STERLING RANCH ROAD & BRIARGATE PARKWAY STORM PLANS

COUNTY OF EL PASO, STATE OF COLORADO
STORM SEWER PLANS
MARCH 2022

CD-Storm_V2.pdf Markup Summary

SHEET **3** OF **23**

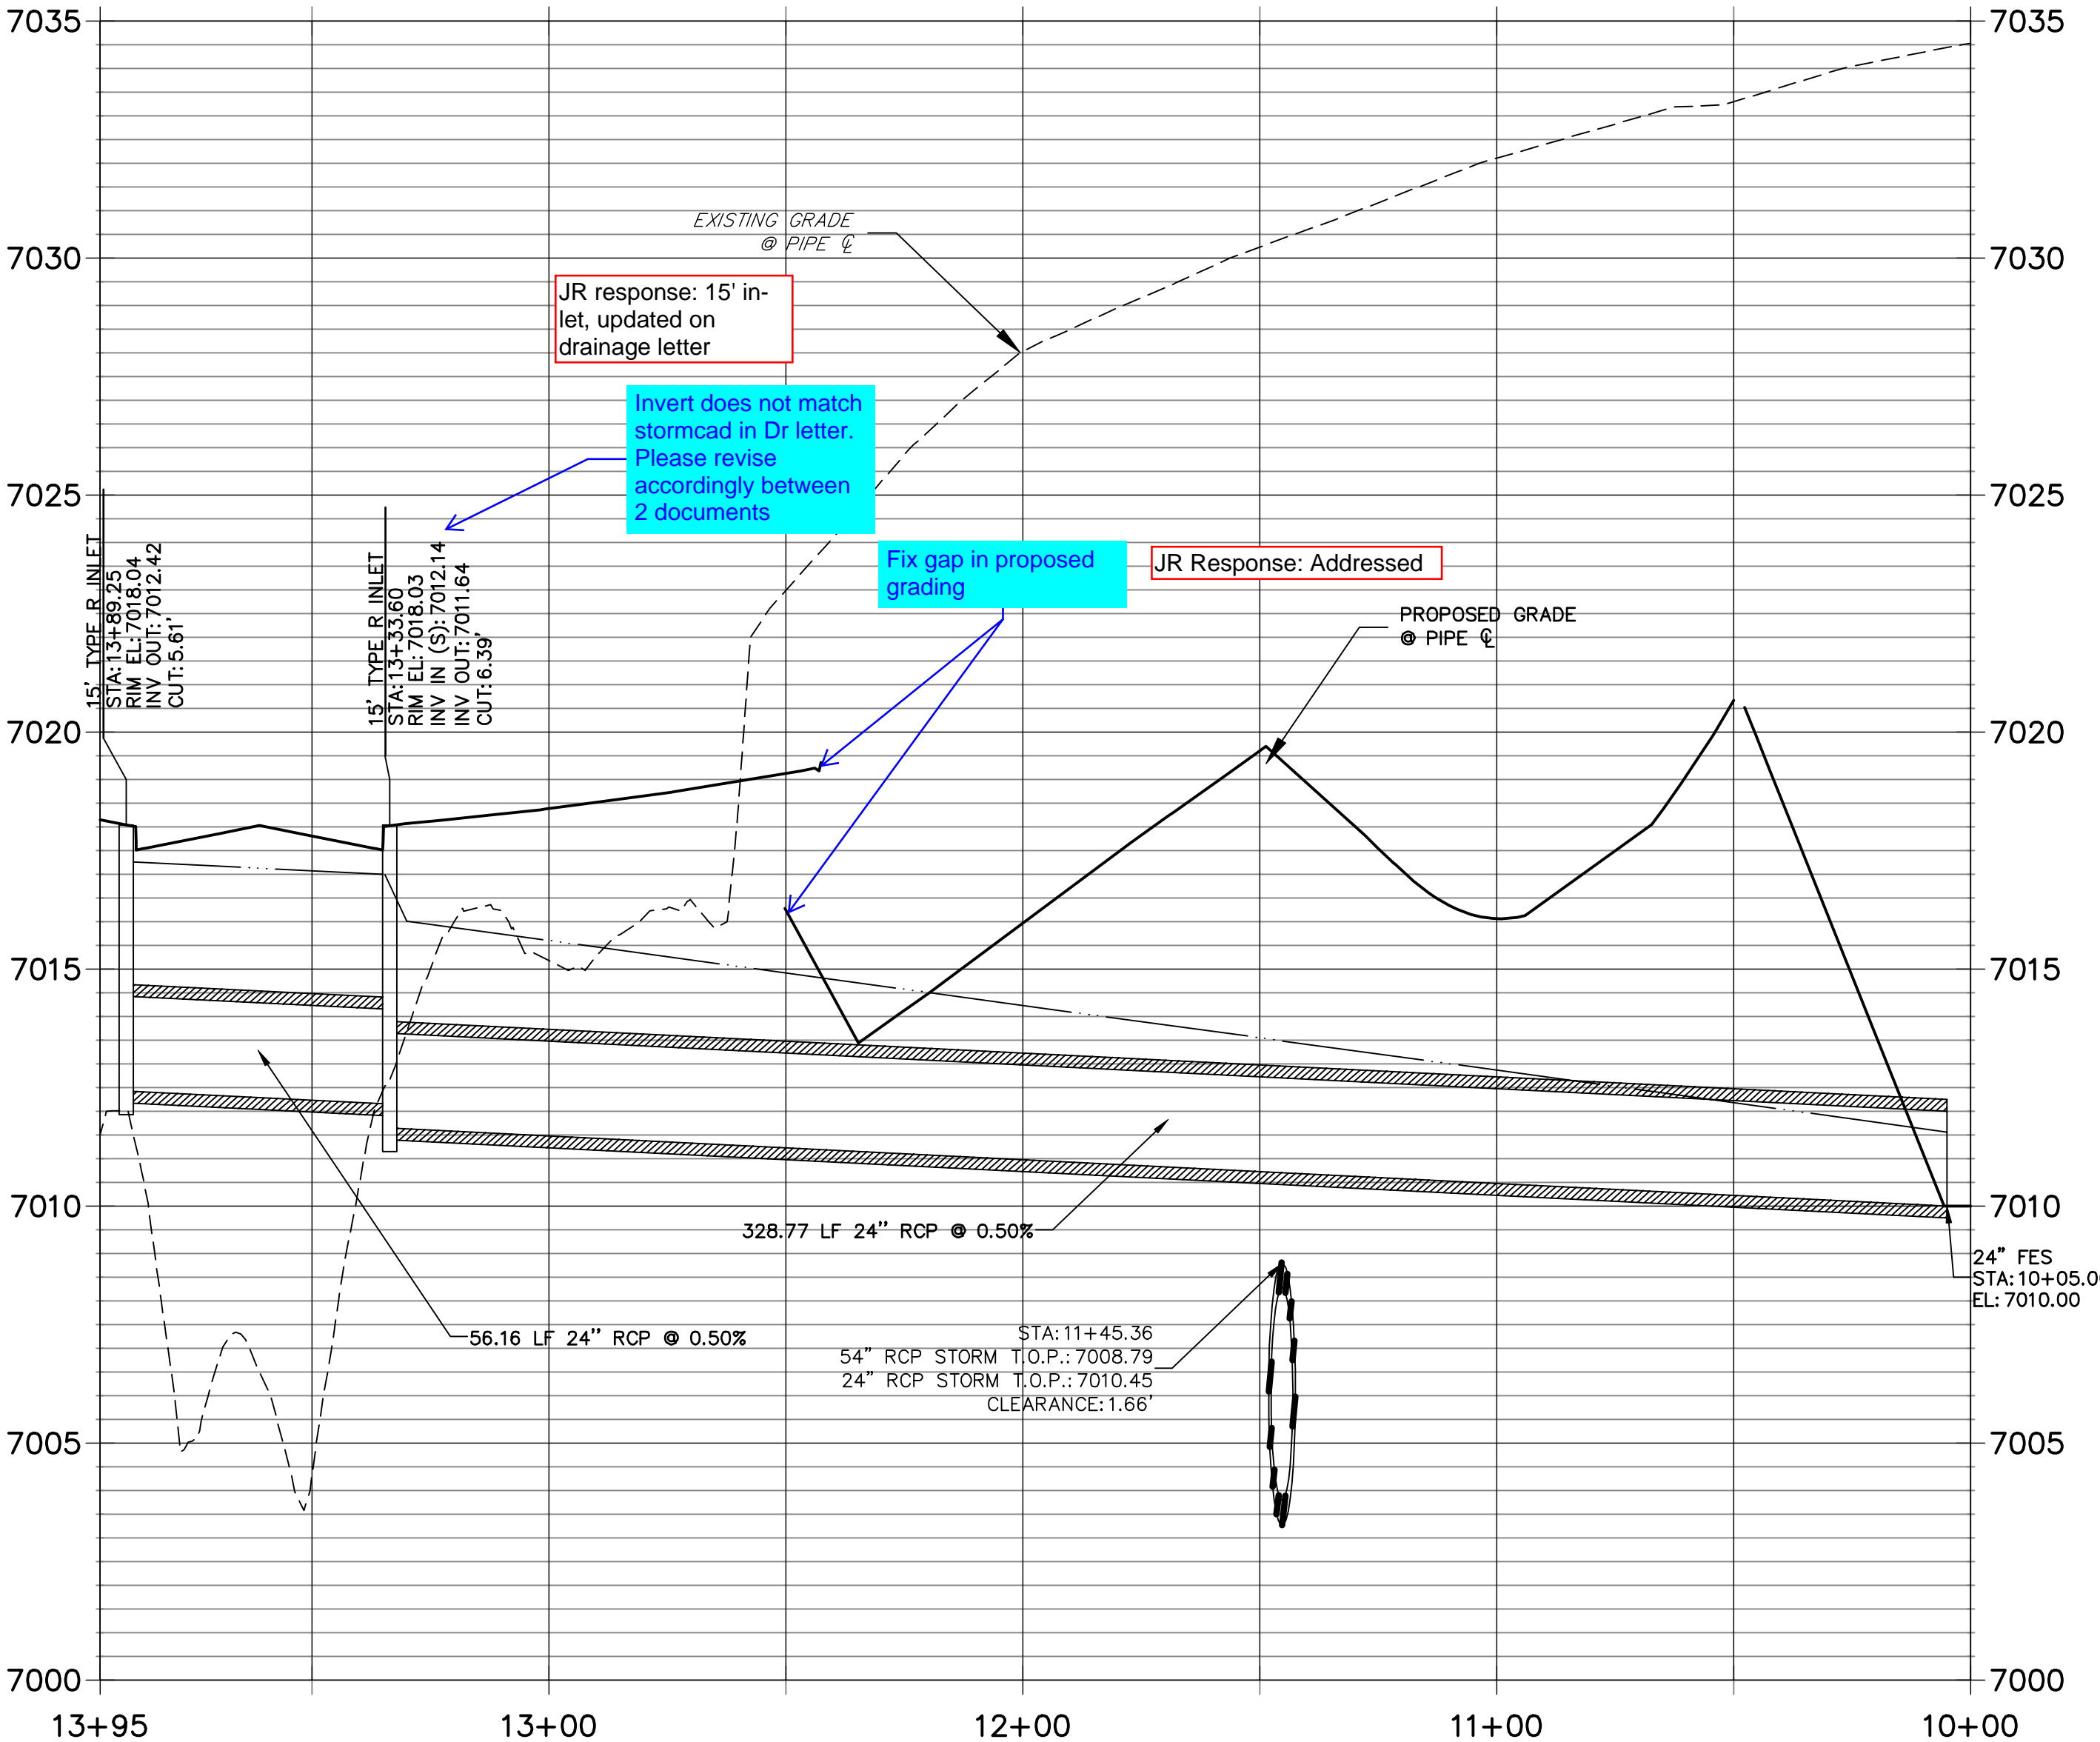
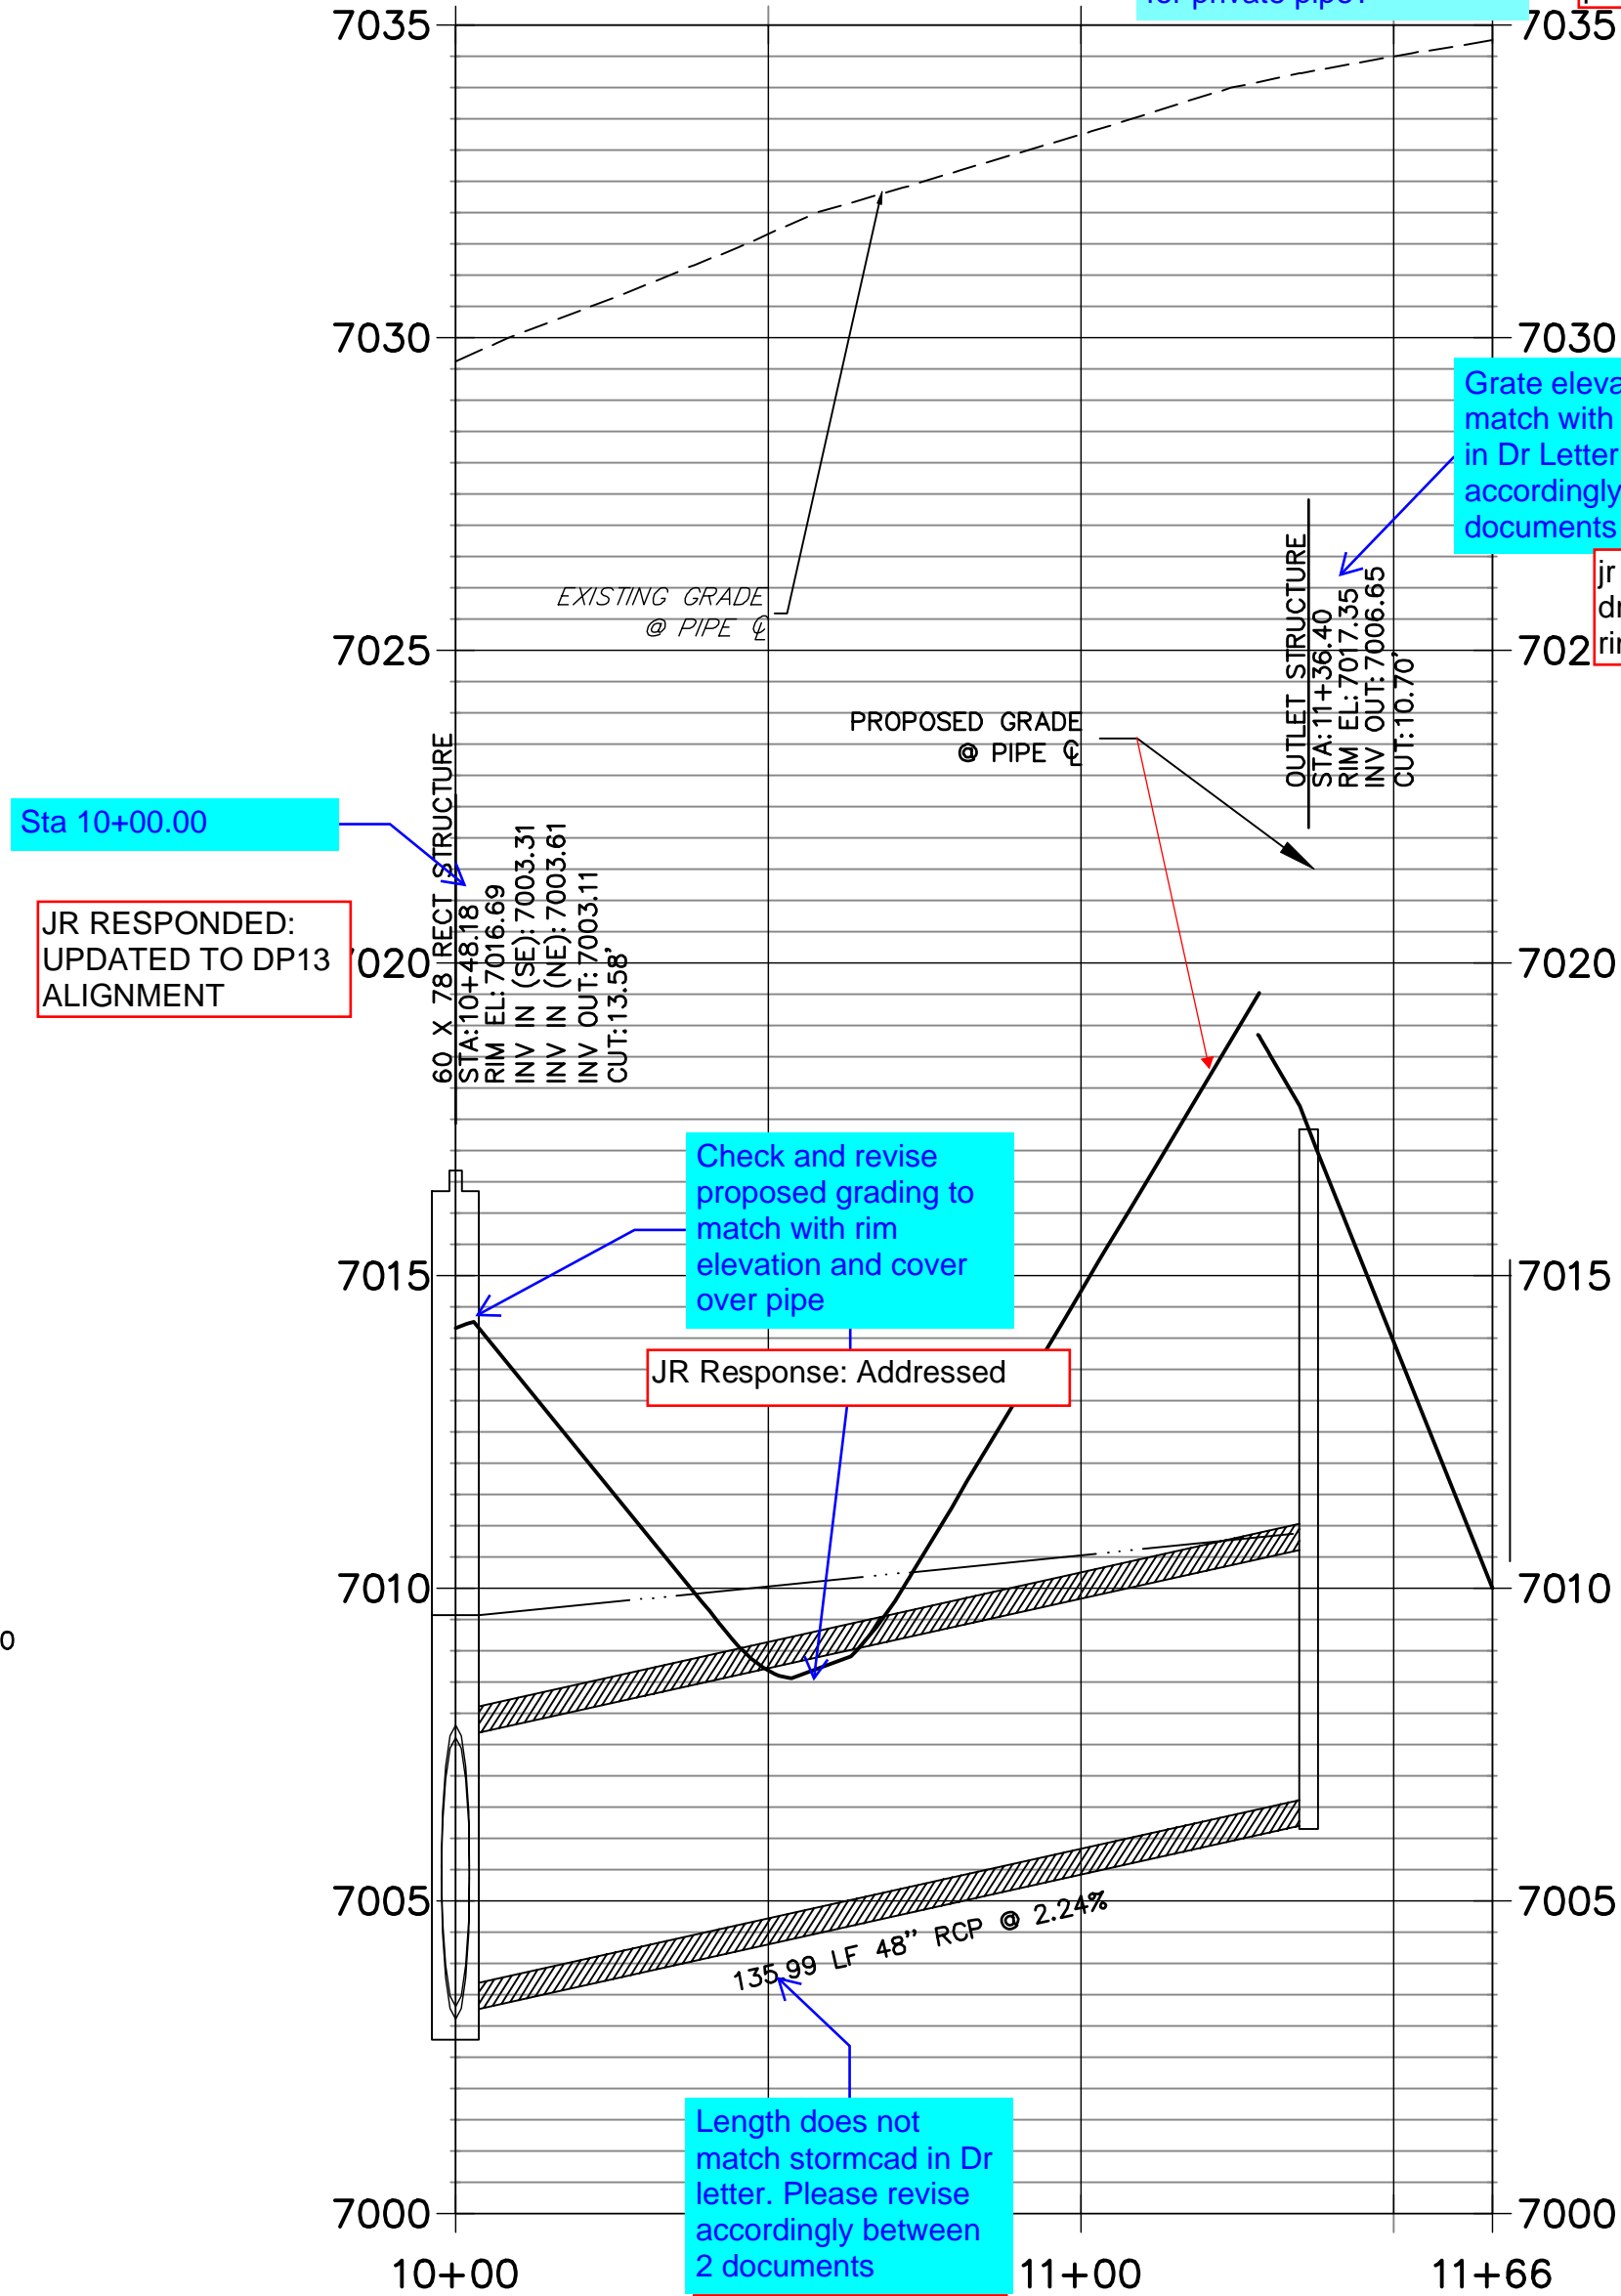
Length does not match stormcad in Dr letter.
Please revise accordingly between 2 documents

Invert does not match stormcad in Dr letter. Please
revise accordingly between 2 documents

Fix gap in proposed grading

10' Inlet per spreadsheet in Dr Letter. Please
revise accordingly between 2 documents

Grate elevation does not match with Pond spreadsheet in Dr Letter. Please revise accordingly between 2 documents

Check and revise proposed grading to match with rim elevation and cover over pipe

Label Pond

See Sheet 20 for details

Label Contours
